**ELKHART HISTORIC & CULTURAL PRESERVATION COMMISSION
FEBRUARY 20, 2025**

A: 24-COA-07 142 State Street – Exterior Renovation

Elkhart Historic & Cultural Preservation Commission
CERTIFICATE OF APPROPRIATENESS
Community Preservation Specialist - Staff Review

Application Number: 25-COA-01

142 State – November 2024 – front façade

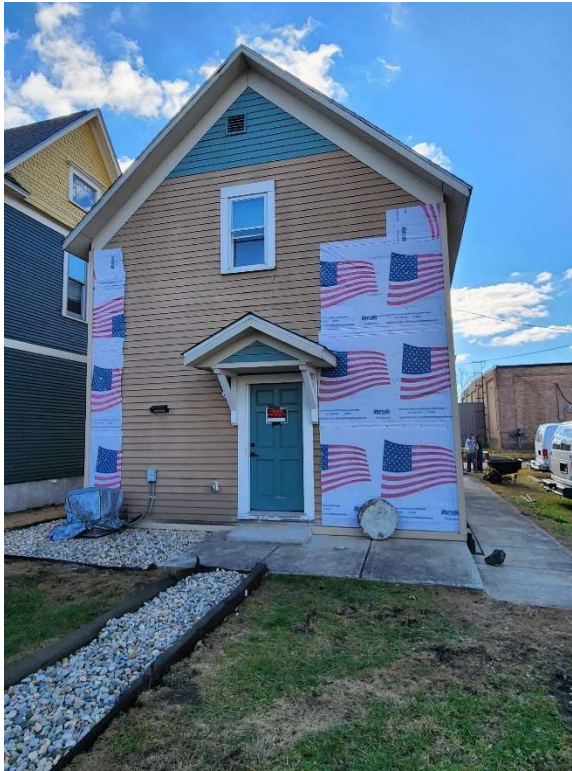
Linley said that looking at the picture that was provided from November 2024 front façade; you got a cute little window up at the top, the color changes at the top, the cool curve at the top of the window, then the fancy front window and those really sad round columns. Linley said that it is an adorable house and it would be wonderful when he gets it done but she questioned what they will do at this point. Whitmer had another question for Parcell in one of her recommendation to discuss it. Whitmer referred to one of Parcell's recommendations about the windows on the west side of the house. Parcell said that those windows are the most visible from the street. Whitmer asked if those are the most important to retained. Parcell responded yes, exactly because that's the city ordinance as well as the state ordinance tells the board as a commission need to review what is visible from the public way. Parcell explained that is hard to see the east side and obviously you cannot see the backside from anywhere but the east side especially because it is a one way street and it is pretty close to the house that LaCasa just finished which makes the east side minimally visible from the street but the west side and south side are very visible that's why those are the two that are really important. Whitmer asked something that was inaudible. Parcell responded yes that's is correct.

1. Windows were purchased in September 2024.
2. As part of COA 24-COA-07 the request to replace existing windows with vinyl windows was denied by the HPC at their December 30, 2024 meeting as stated in the decision letter:
“Windows - denial of the request for replacement with vinyl windows. The existing windows should be repaired and retained where possible. The lead paint will be encapsulated or removed at a minimum for the street facing windows. The west façade windows should be retained. The windows not public facing (east and north) can be replaced with other material as needed. A storm window be used to retain the multi pane look also for the transom window above the door. The new windows not be vinyl rather a fiberglass or aluminum clad maintaining the original proportions, two over two (2/2). New windows shall have applied grid spacers to the glass not between the glass. The curved detail over the windows shall also be retained. Approved 5-0”

3. Encapsulation and/or removal of lead paint is the preferred approach over wholesale replacement of windows.
4. Vinyl windows are generally not approved in the historic district, particularly on street-facing sides.

The fact the owner did not disclose windows had already been purchased on 24-COA-07 application does not materially change the recommendation for denial, as the purchased windows do not meet the guidelines in material or design.

East Façade – 2024

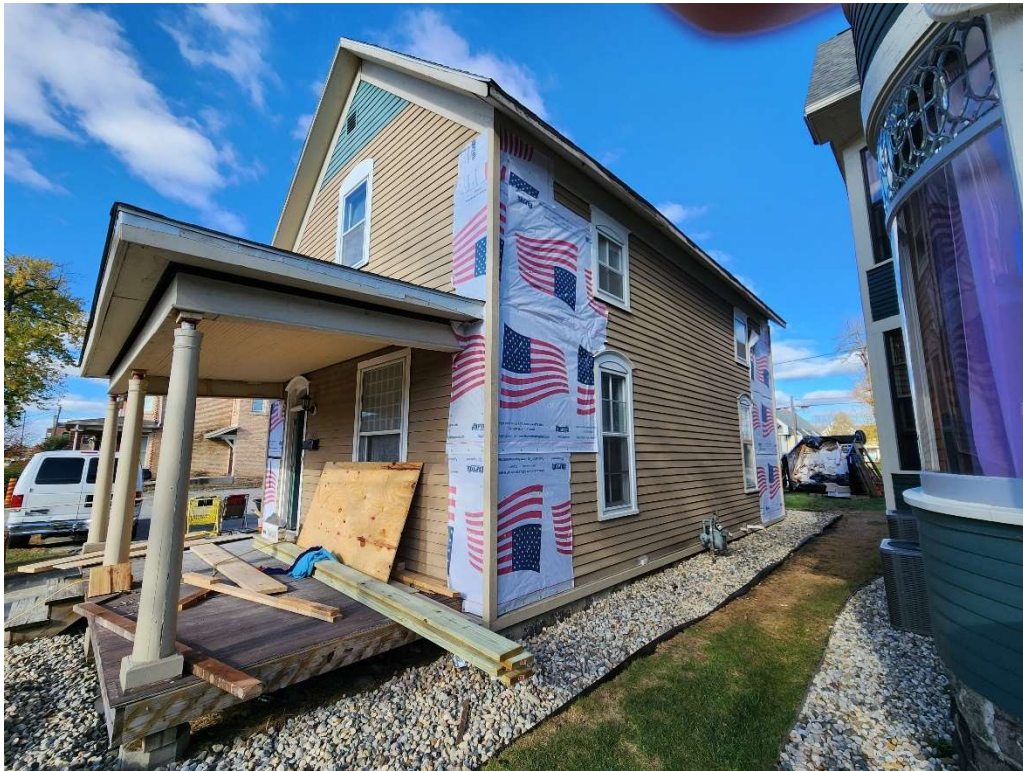
Linley asked Parcell if the current windows are two over two. Parcell responded that some of them are. Linley added that nothing mostly one over one. Parcell told Linley to look at the picture of the east façade which are two over two but she was not able to say that all of them were the same way. A question was asked but it was inaudible. Parcell responded undoubtedly there is probably various kinds. Parcell said that the most defining features definitely is a two over two probably is the original window and keeping that where it is and looking at the side view those curved areas above the windows, that trim is very distinctive, not what's in the front, that upper window above the porch that's somebody failed attempt at mimicking what's on the side and that is not an original thing. Parcell referred back at the earlier photos in 2003 there was nothing above that window and somebody created something that does not look cool. Whitmer added as a contractor you can create something better to match the size. Parcell said something to look like it's there and added that's a very distinctive feature and also very visible because it is in the west side. Linley said that it is very cool. Parcell said that they did the same thing above the front doors which has the same thing above the transom and that's a very distinctive which makes it really attractive. Linley said that they cannot see it clearly in the pictures but Parcell mentioned that the front window that is protected by the porch has a very elaborated top piece to it. Parcell said yes and added that there are a lot of little divisions to it. Linley asked if there was hope of saving that. Parcell responded that she hoped that the front window could be save. Whitmer added that it has been protected from the elements and it should be in better conditions. Linley asked if there was something they could do something to protect it and save it. Jones responded that it is a single pane window and as far
